A.1 Summary of Field Observations

Submission 74

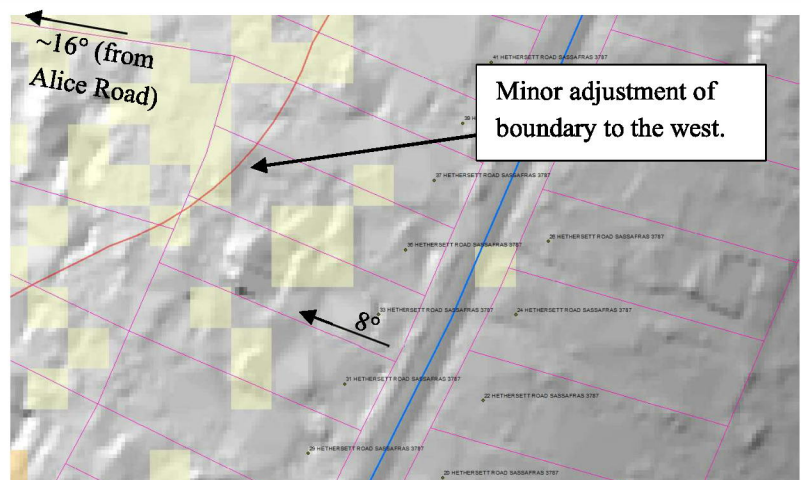
The natural slope angle at the eastern end of the property is 8° , below the threshold for inclusion. The natural slope angles on the properties to the west of 35 Hethersett Road (16 to 20 Alice Road) were measured to be 14° to 20° which is above the threshold for inclusion.

There is some scope to map in finer detail and to make minor adjustments to the boundary towards the west to align with areas of denser mapped susceptibility.

Submission 76

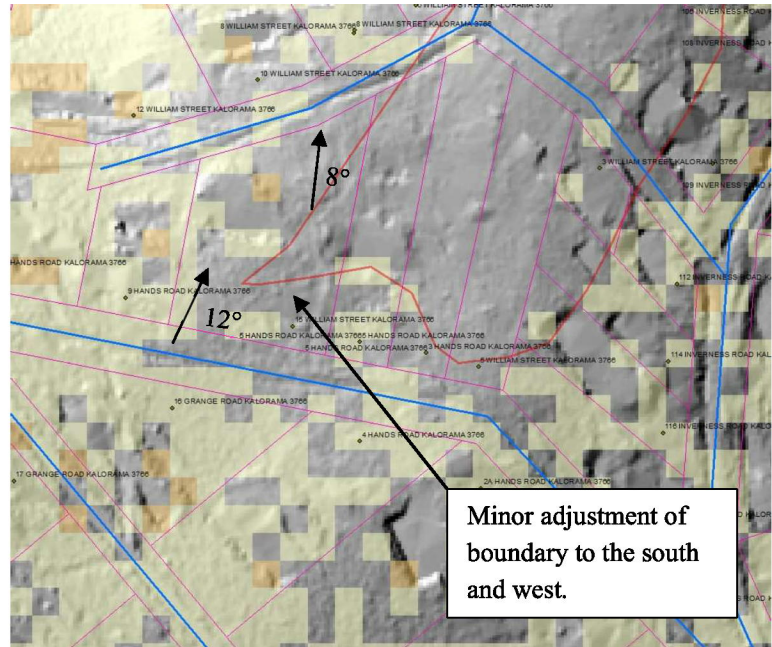
Natural slope angles are 8° at the William Street end of the property, 10° in the south east corner and 12° to 13° at the south west corner of the property, adjacent to Hands Road. The slope in the south west corner of the property has a slope angle above property is below the threshold for inclusion in the EMO.

There is scope to map at a finer scale and to make minor adjustments to the boundary on the south and west to western side of the property to better align with areas of denser mapped susceptibility.

Submission 77

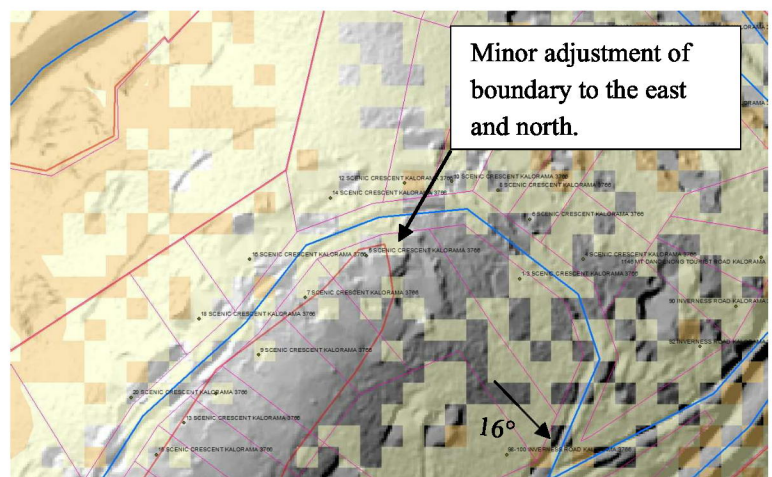
Natural slope angles in the south east part of the property are 16° , which is above the threshold for landslide susceptibility. The north west area of the property becomes flat at the crest of the ridge.

There is scope for more detailed mapping and minor adjustment of the boundary towards the east and north to align with areas of denser mapped susceptibility.
